Date: November 30, 2023
To: All Vendors
Subject: Addendum #2

**REFERENCE: B014-24 Re-Bid BPUB Downtown Wastewater Improvements-ARPA
Project 1**

Project:	Brownsville PUB – Downtown Wastewater Improvements ARPA Project 1 BPUB Bid No. B014-24	Addendum Date:	November 30, 2023
From:	Javier A. Esquivel, PE	Project No.:	BPUB2200025.01

ADDENDUM No. 2

SHEET
 CC03

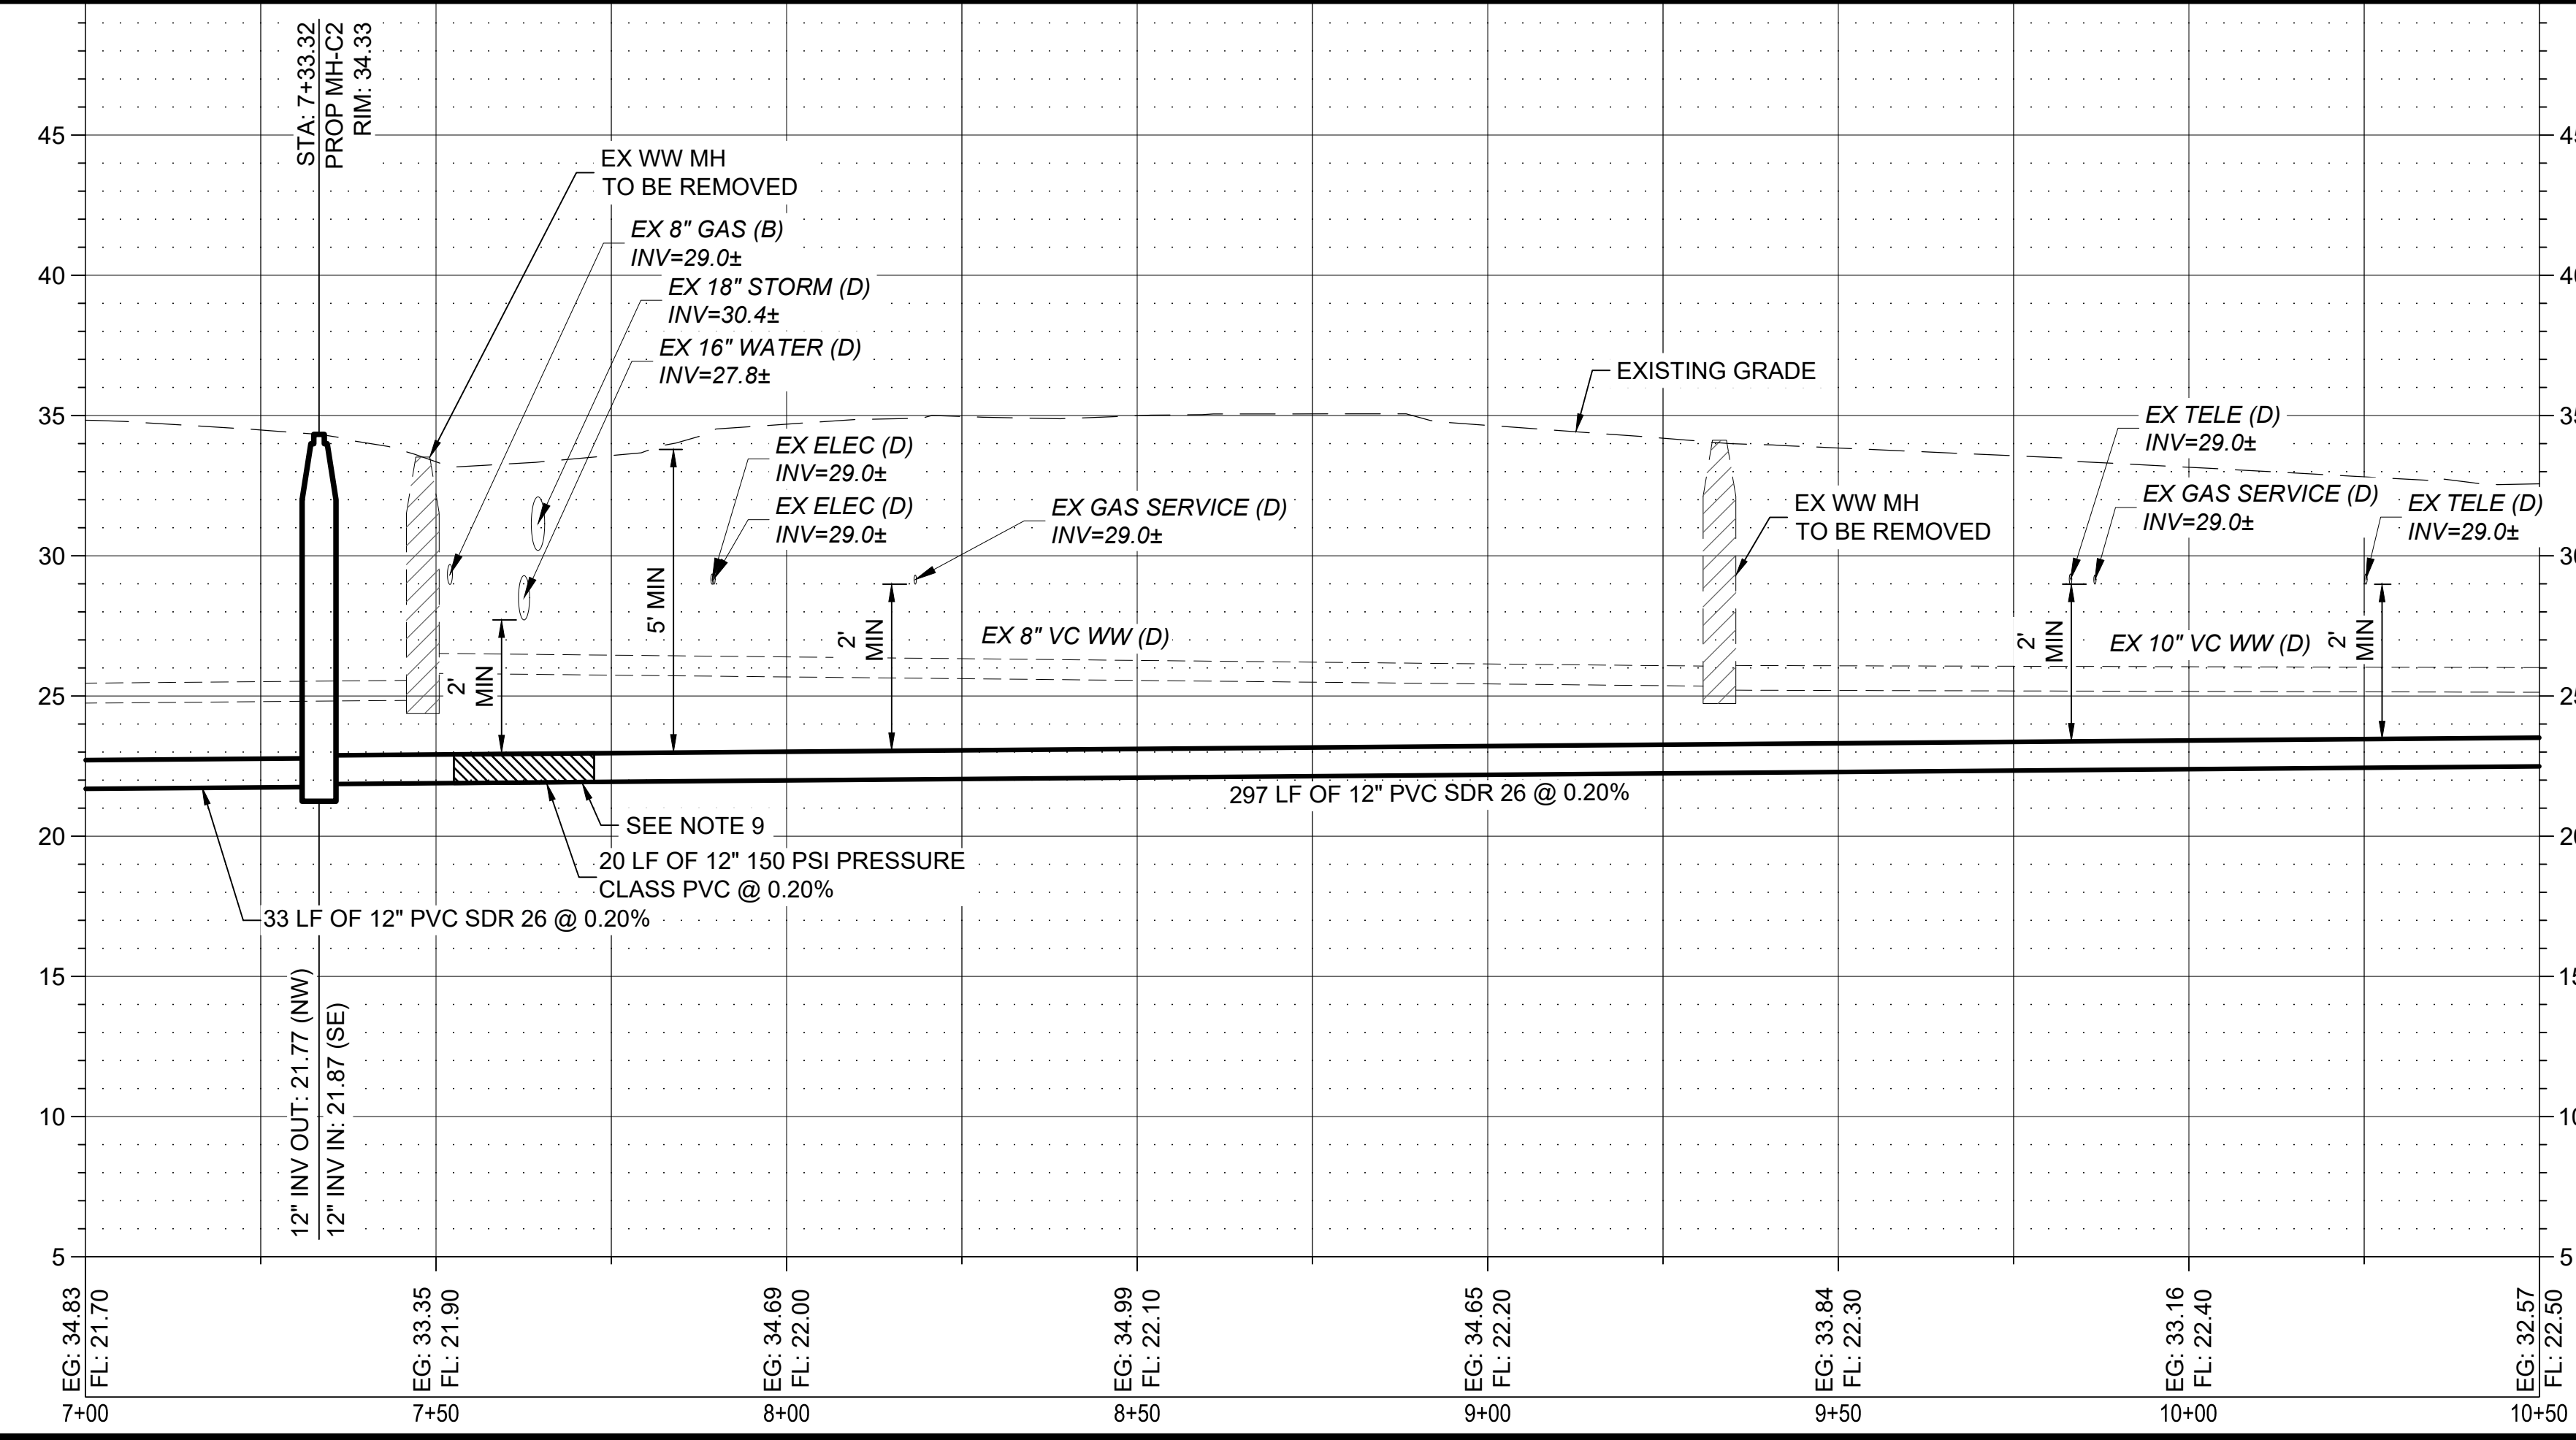
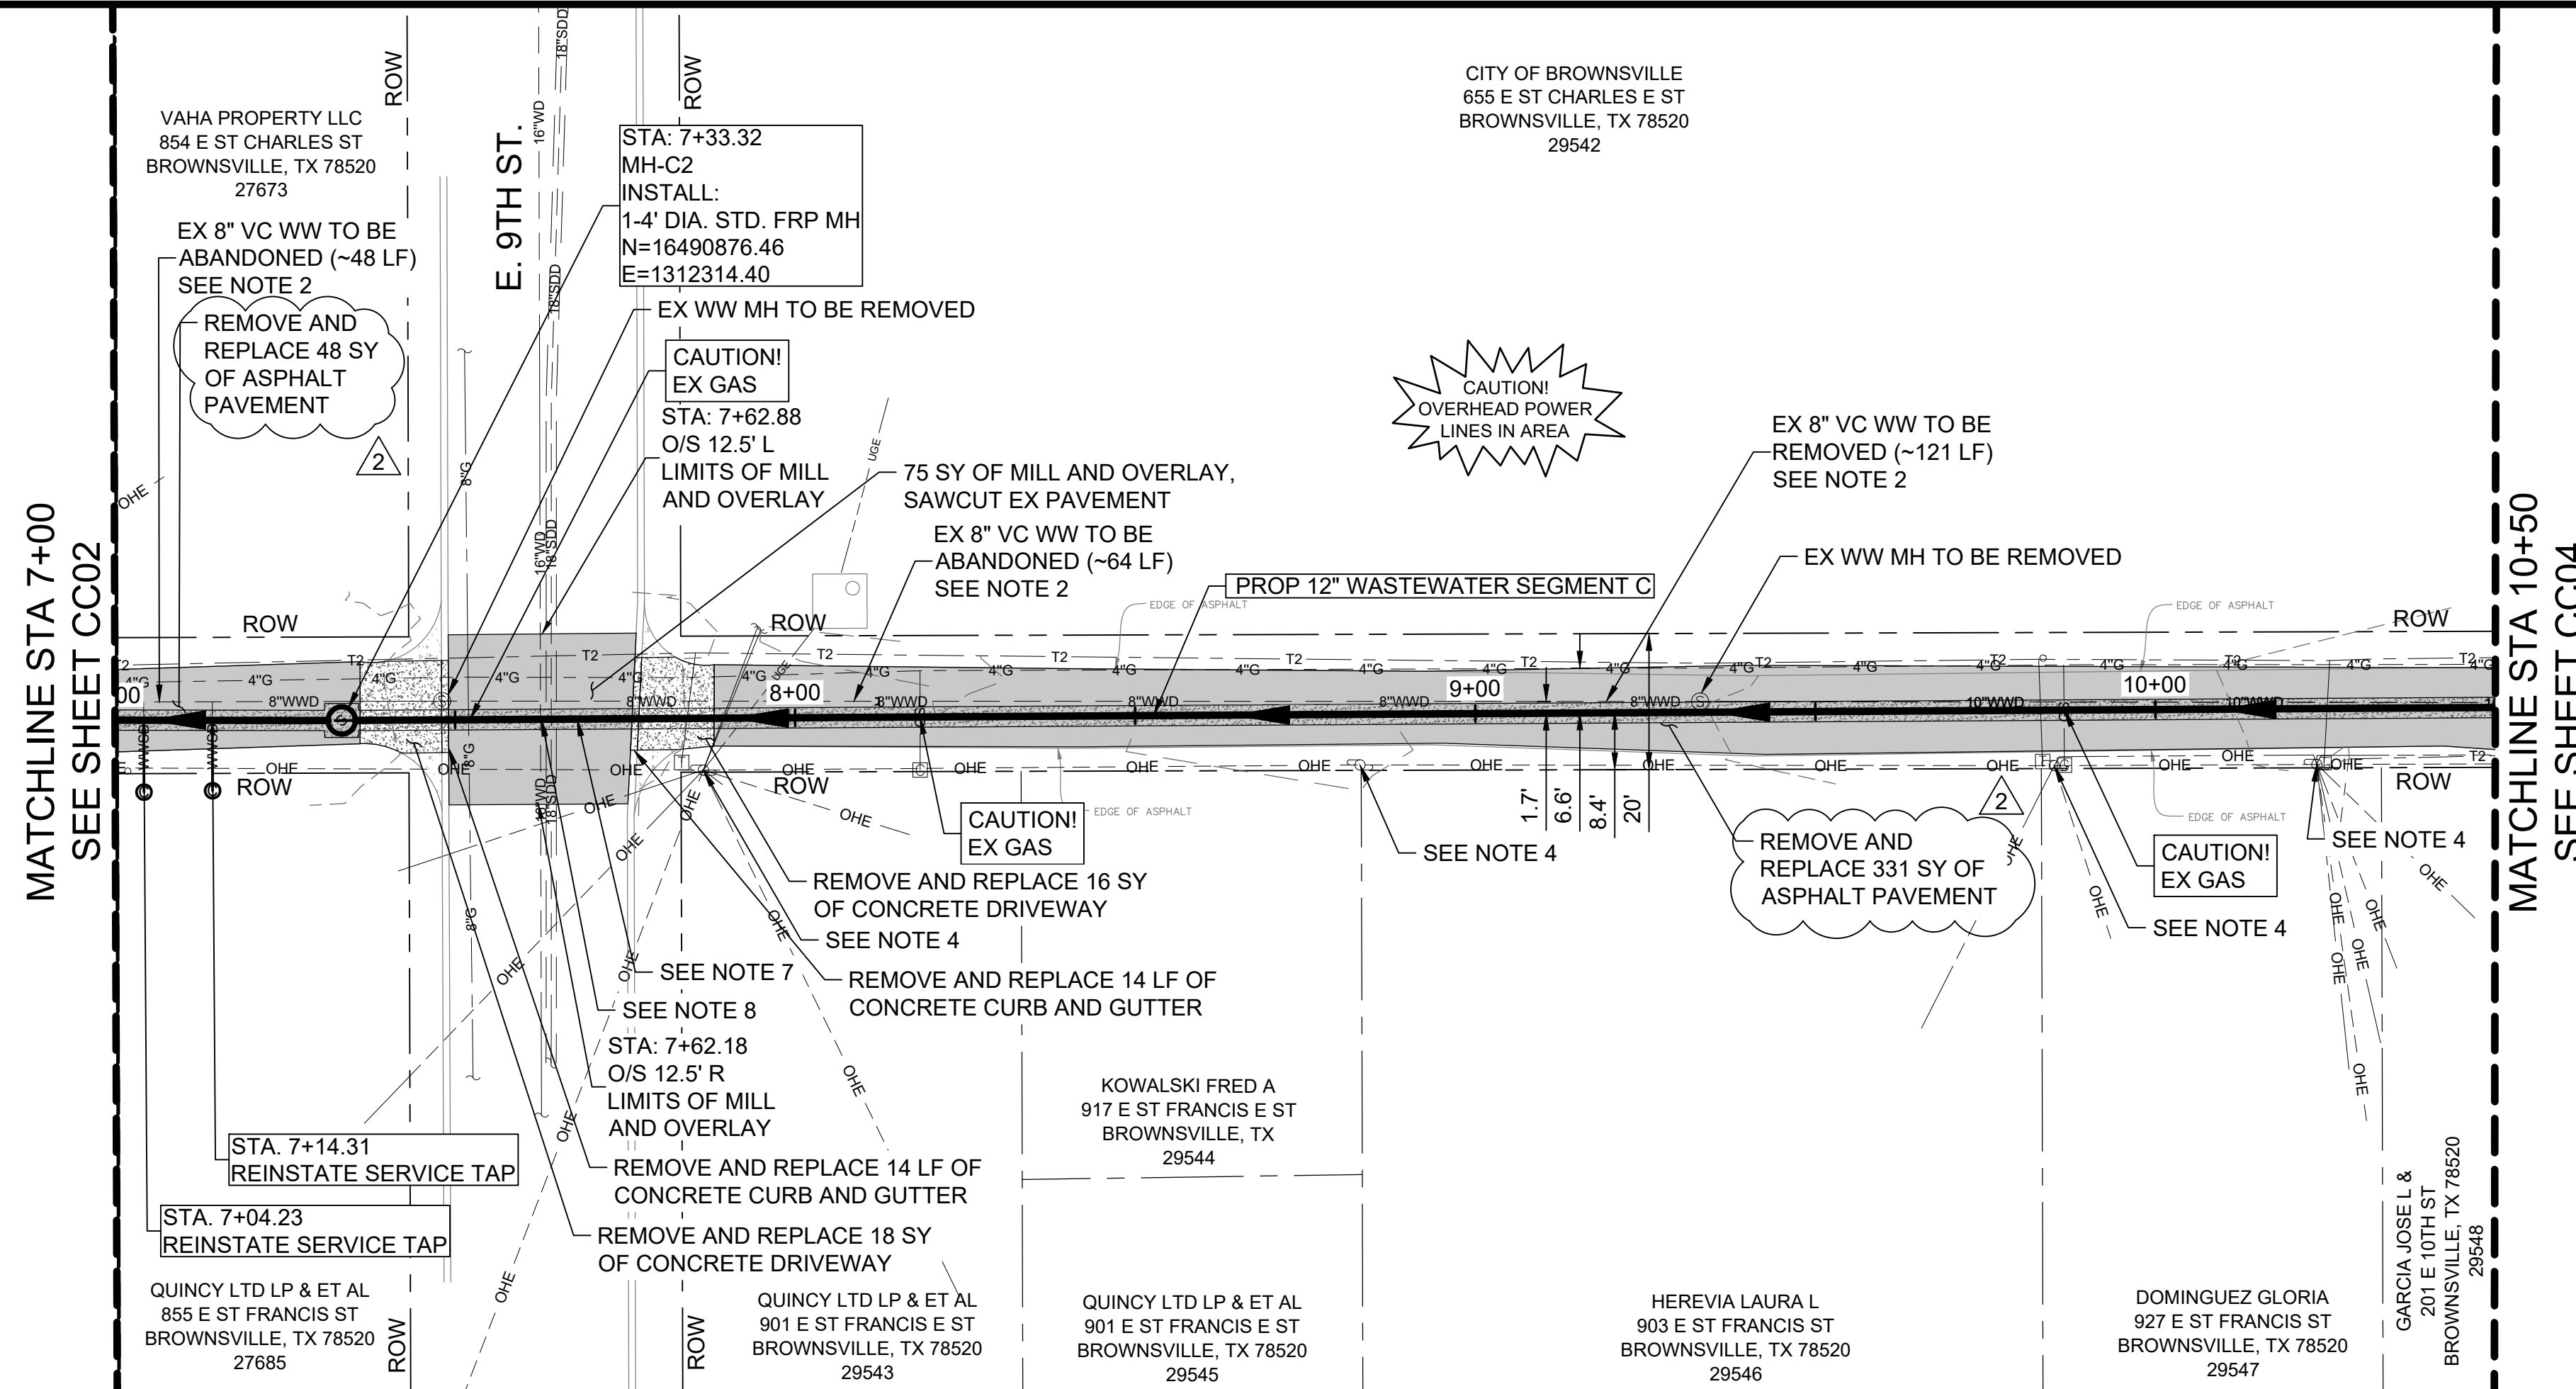
1. Revisions to Surface Restoration in the Alleys.
 - Segment A: Replace Mill and Overlay (2”) with full depth concrete asphalt pavement removal and replacement.
 - Segment B: Replace Mill and Overlay (2”) with full depth asphalt pavement removal and replacement.
 - Segment C: Replace Mill and Overlay (2”) with full depth asphalt pavement removal and replacement.

3. Plan Sheets: The following plan sheets were modified to update surface restorations CA02, CA03, CA04, CA05, CA06, CA07, CB01, CB02, CB03, CC02, CC03, CC04, and CC05.
